# Model Administrative Change Notice

<b>1. Document Number:</b>	MDL-MGR-GS-000003	<b>2. Revision:</b>	01	<b>3. ACN:</b>	01
<b>4. Title:</b>	Development of Earthquake Ground Motion Input for Preclosure Seismic Design and Postclosure Performance Assessment of a Geologic Repository at Yucca Mountain, NV				
<b>5. No. of Pages Attached</b>	9

<b>6. Approvals:</b>		
<b>Preparer:</b>	Richard C. Quittmeyer Print name and sign 	11/28/2005 Date
<b>Checker:</b>	Ming Lin Print name and sign 	11/28/2005 Date
<b>QER:</b>	Darrell Svalstad Print name and sign 	11/28/2005 Date
<b>Independent Technical Reviewer:</b>	Jean Younker Print name and sign 	11-28-05 Date
<b>Responsible Manager:</b>	Paul Dixon Print name and sign 	11-29-05 Date

Figure 6.2-1. Hazard Curve at Point A for Peak Horizontal Ground Acceleration

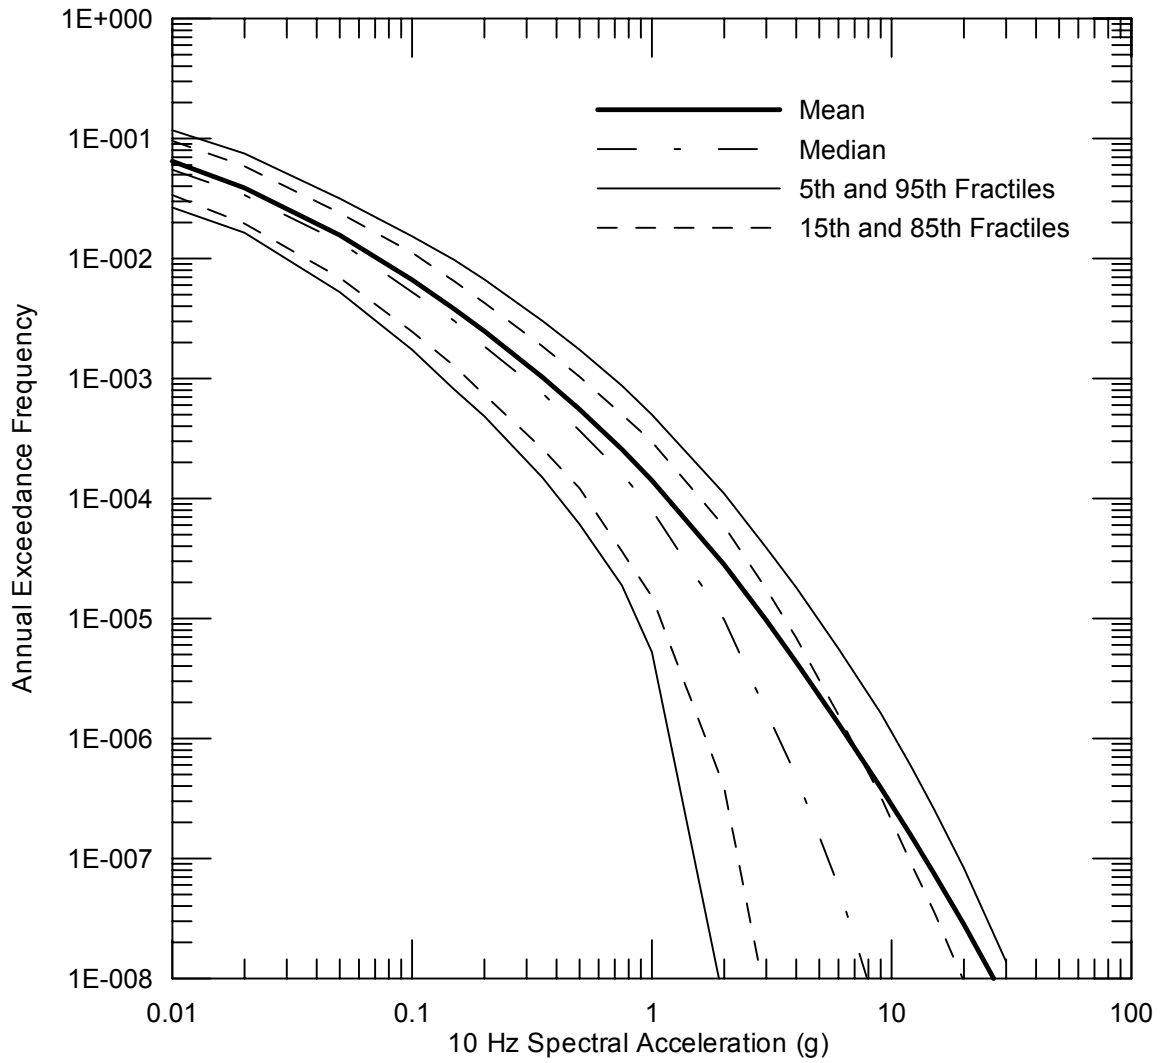
7. Affected Pages	8. Description of Change:
6-84 through 6-87	<p>Editorial changes to captures in Figures 6.2-1, 6.2-2, 6.2-3, and 6.2-4.</p> <p>As described in Condition Report 6134, the graphic componenets of Figures 6.2-1 through 6.2-4 are scrambled and need to be changed to agree with their captions, which are correct:</p> <ul style="list-style-type: none"> <li>• The graphic componenet of Figure 6.2-1 is exchanged with the graphic component of Figure 6.2-4 such that Figure 6.2-1 shows the hazard curve for Point A for peak horizontal ground acceleration and Figure 6.2-4 shows the hazard curve for Point A for peak horizontal ground velocity.</li> <li>• The graphic componenet of Figure 6.2-2 is exchanged with the graphic component of Figure 6.2-3 such that Figure 6.2-2 shows the hazard curve at Point A for 10 Hz horizontal spectral acceleration and Figure 6.2-3 show the hazard curve at Point A for 1 Hz horizontal spectral acceleration.</li> </ul> <p>This change was identified in CR 6134</p>
